**PRM-50-95
(75FR66007)**

Subject: Response to the U.S. Nuclear Regulatory Commission's ("NRC") notice of solicitation of public comments on PRM-50-93 and PRM-50-95; NRC-2009-0554

COMMENTS ON PRM-50-93 AND PRM-50-95; NRC-2009-0554

II. Response to NEI’s Comments on PRM-50-93 and PRM-50-95, Dated November 24, 2010.....6

Fig. 16: CORA-16; Temperatures of unheated rods

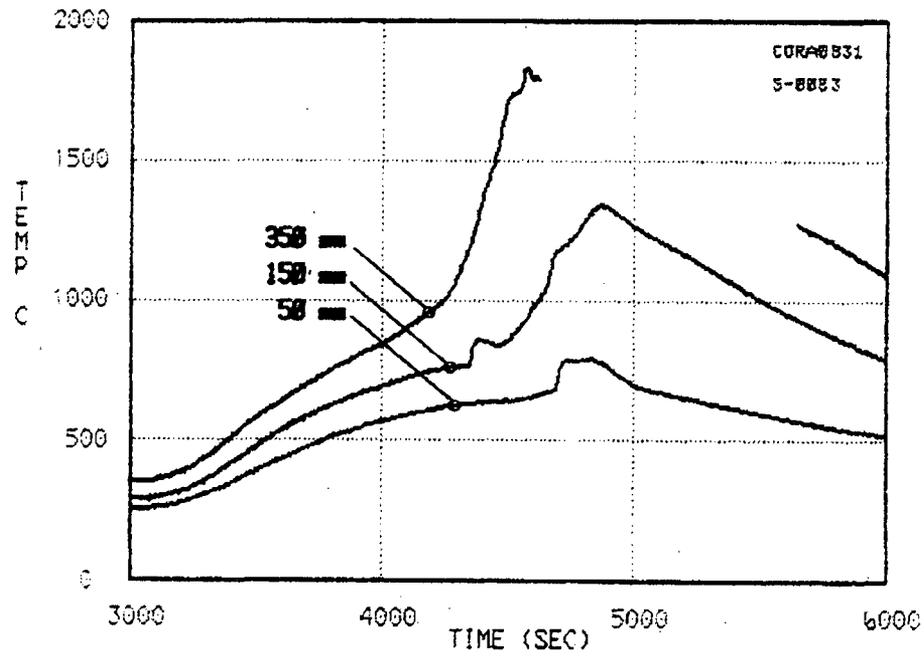
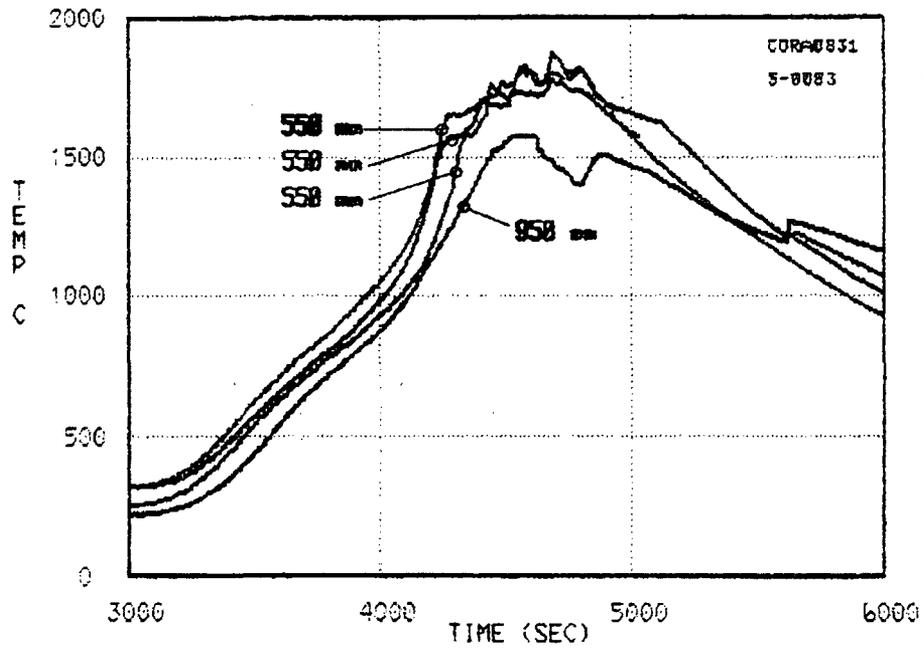
First, NEI is correct that the temperature of the BWR cruciform control blades would be significantly below that of peak fuel cladding temperatures, in the event of a LOCA, as demonstrated by the CORA-16 experiment. However, if the fuel cladding were to incur runaway oxidation between 1832°F and 2192°F, peak cladding

¹¹¹ See Appendix A Figure 16. CORA-16; Temperatures of Unheated Rods and Figure 17. CORA-16; Temperatures of the Absorber Blade.
